We act for [REDACTED] has passed to us your Notice dated 21 March 2024 served under the Flood Risk Management (Sc) Act 2009 and invited us to lodge [REDACTED] objections on his behalf as a relevant objector in terms of that legislation.

**The following therefore should be treated as his Statement of Reasons for [REDACTED] objection to the proposed Scheme.**

FIELD 5  
BACK  
PARK

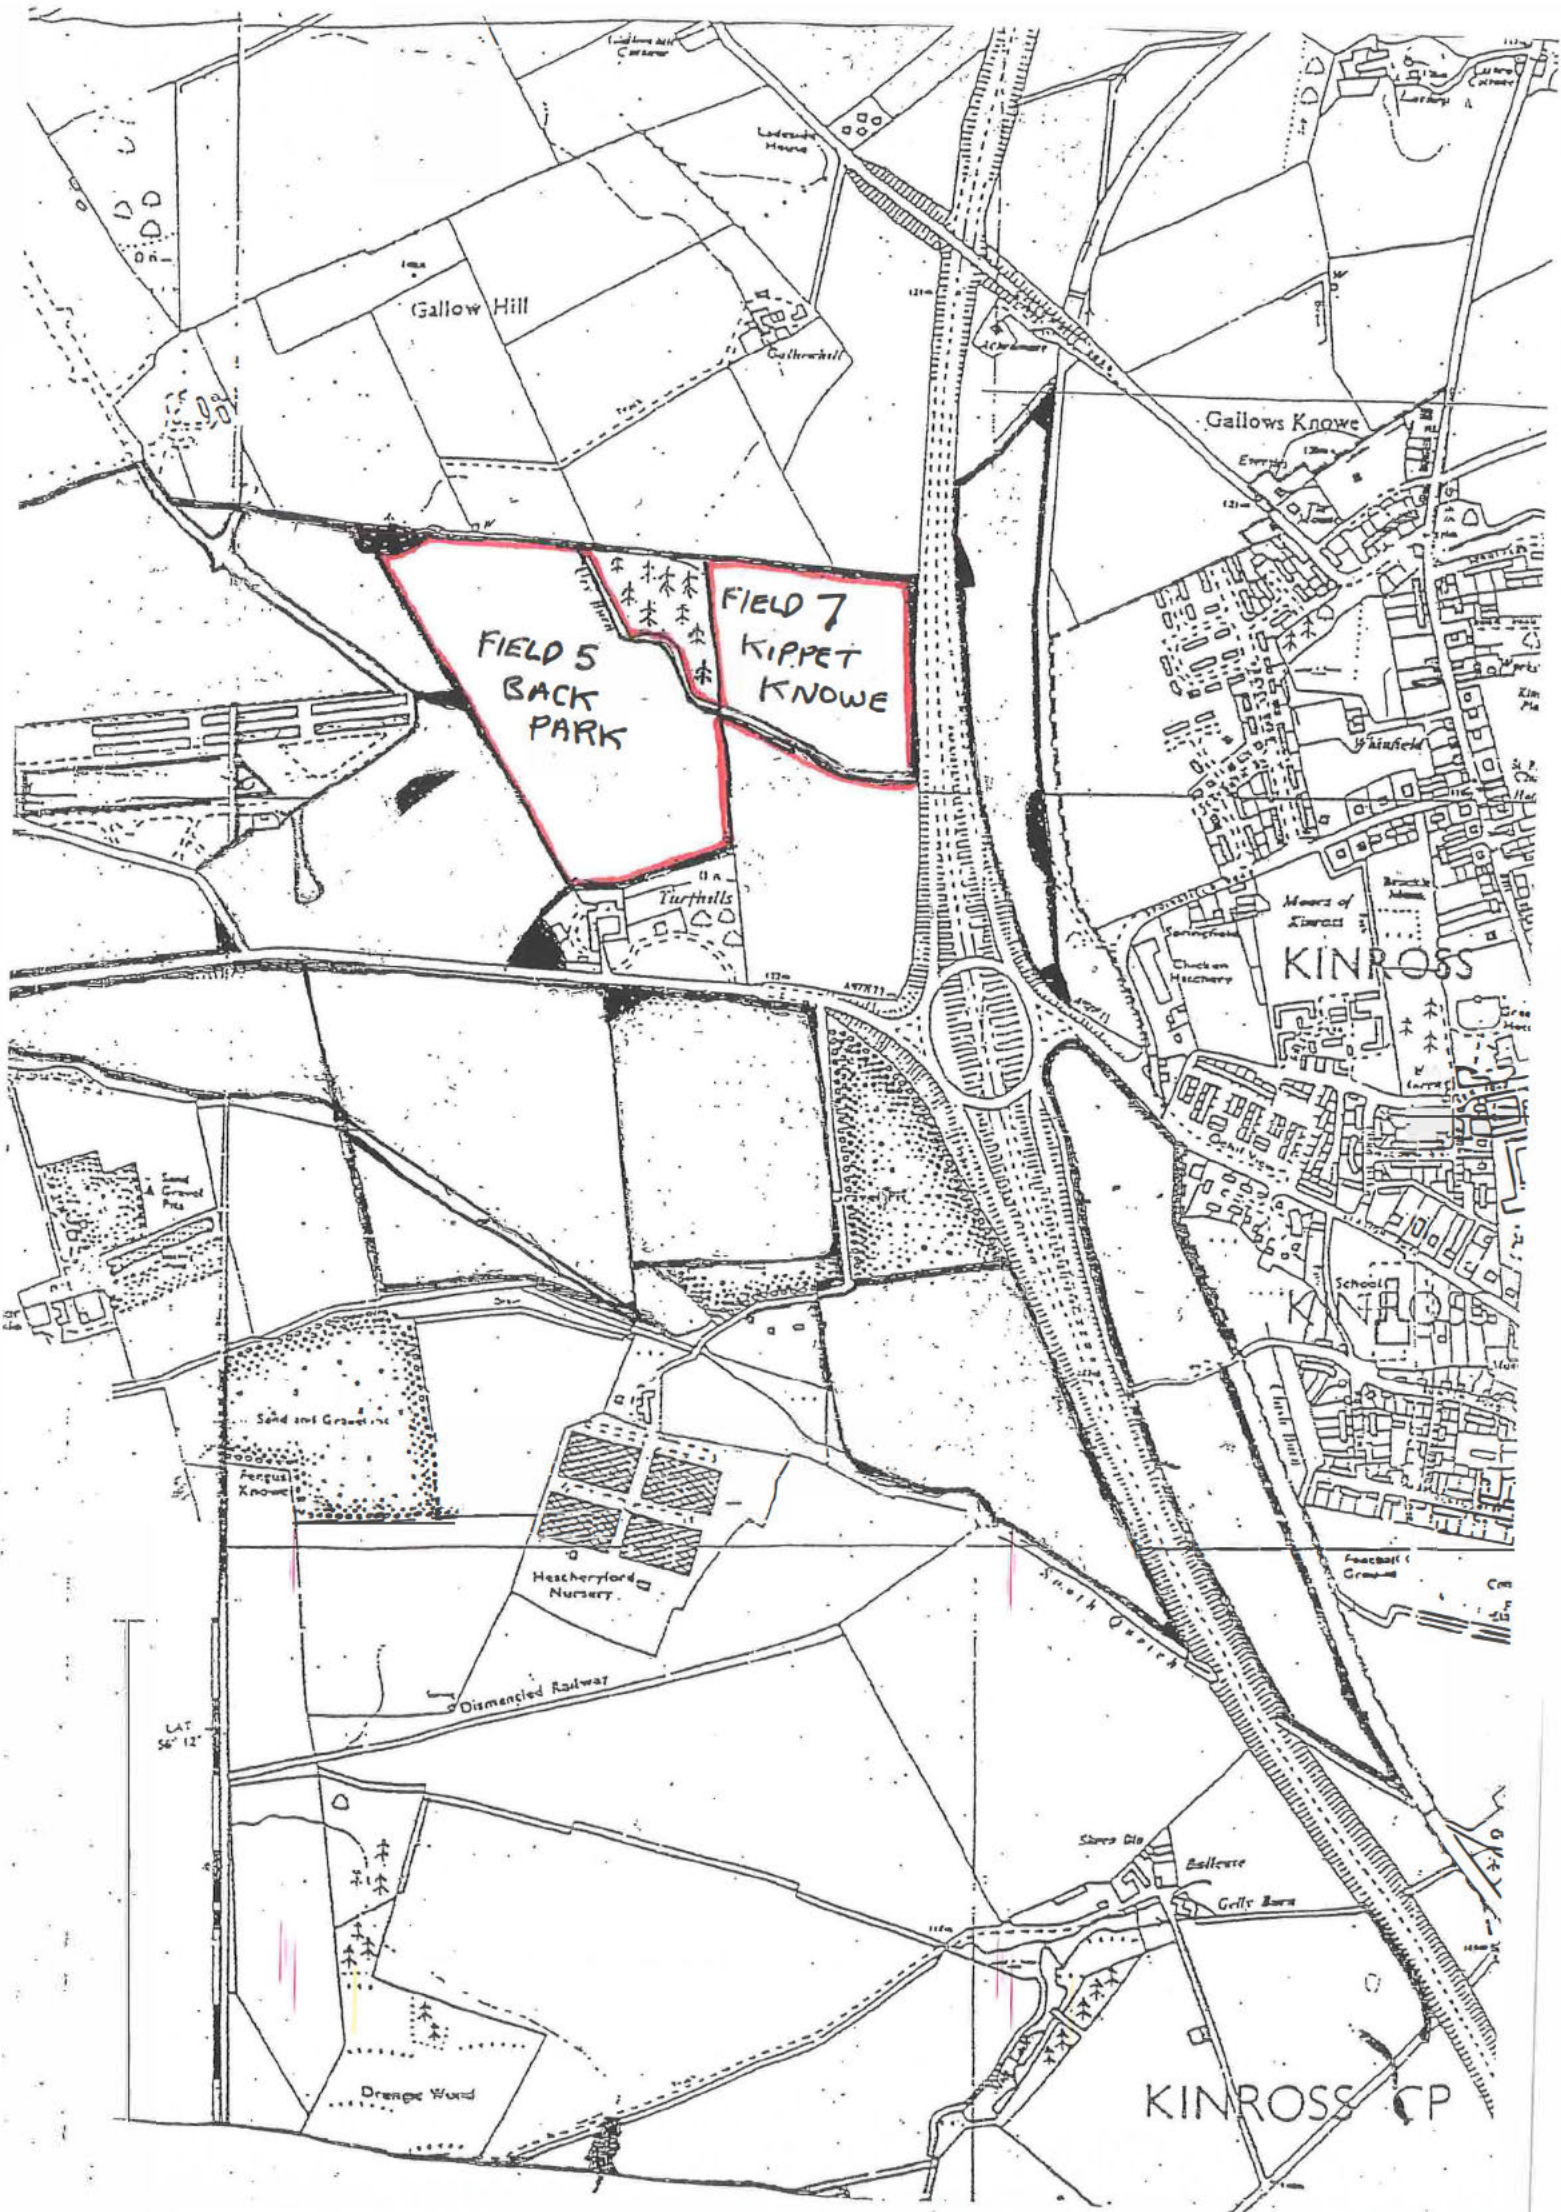
You have identified one of his fields, known as the Back Park field, lying to the west of the M90 and to the north of Kinross services, as being the location for your intended storage embankment if the proposed South Kinross Flood Protection Scheme 2024 ("the Scheme") goes ahead. We attach a plan showing [REDACTED] Back Park field as well as [REDACTED] field to the east thereof known as the Kippet Knowe field which will also be affected by your intended operations.

You will see from SEPA's own flood risk map of the area, attached, that the location of [REDACTED] Back Park field is subject to a flood risk representing between 0.1 to 0.5% chance of flooding each year. This is shown by the lightest blue and mid blue colours on the attached plan. One suspects that this maybe mainly due to the close proximity of the adjacent Ury Burn, potentially flooding the field, and not as a result of water flowing overland from the South Queich.

The South Queich is shown on the said plan and you will see that it runs much further south, through lands to the south of the A977 roadway before running under the M90 towards south Kinross. You will note the colourings there, mid blue and dark blue suggesting a greater risk of flooding in those specific localities. It is hard to comprehend how any modelling would suggest that the South Queich (which lies some 2 miles distant) would end up pooling in the Back Park field. SEPA's map shows no flooding in this field at all. This is something that has never happened in the preceding [REDACTED] years that the lands have been owned by [REDACTED] and [REDACTED] family. There are many other properties that would be affected by such a waterflow (such as the chicken sheds, the "Golf Ball" site, houses and Kinross services) before it would reach the Back Park field. If any such flood defence is needed, it should be much closer to the South Queich itself.
